# A d d e n d u m

Iowa Department of Transportation  
Office of Contracts

<b>B.O.</b>	<b>Proposal ID</b>	<b>Proposal Work Type</b>	<b>County</b>	<b>Project Number</b>	<b>Addendum</b>
101	31-2100-675	PCC SIDEWALK / TRAIL	DUBUQUE	SB-IA-2100(675)--7T-31	15SEP101.A01

Plan Sheet U.34

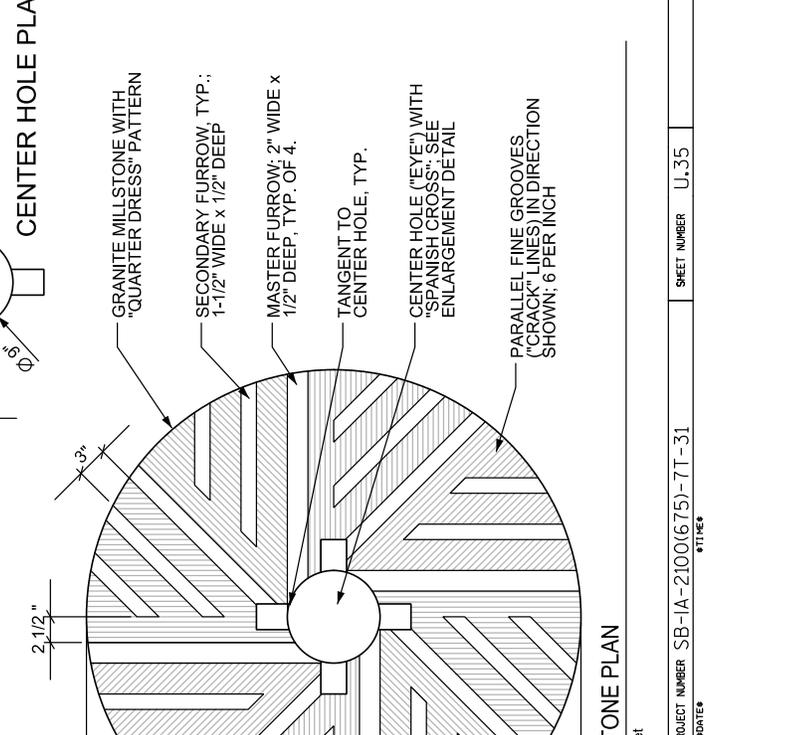
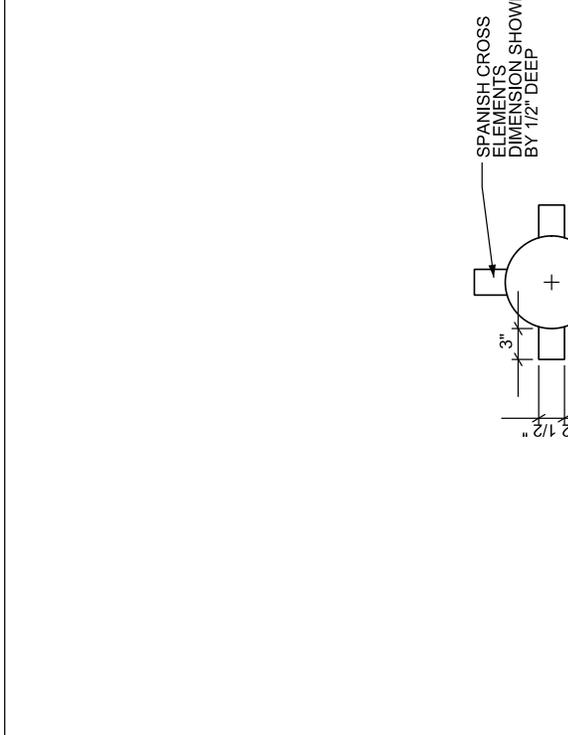
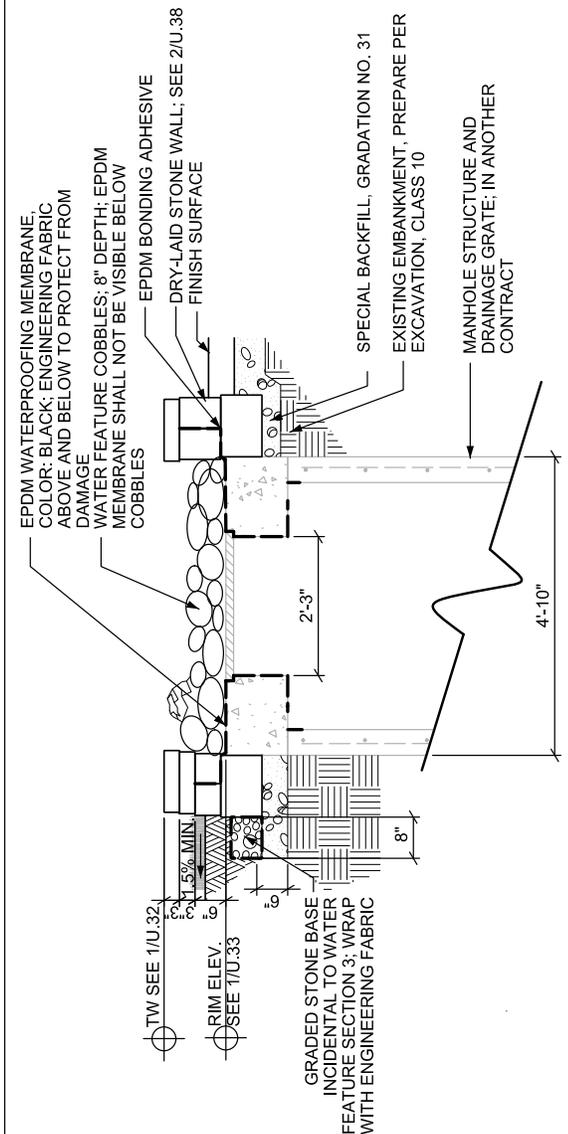
Replace the following text within DETAIL 1 WATER FEATURE SECTION 1:  
MILLSTONE-WATERFALL:

From: 6" pipe w/bell end to support 100-300 GPM flow rate;  
Seal millstone to pipe with elastomeric sealant,  
Insert Neenah R-4270-1 type grate into bell end.

To: 6" pipe w/bell end and grate by Contract 1-2015,  
Seal millstone to pipe with elastomeric sealant.
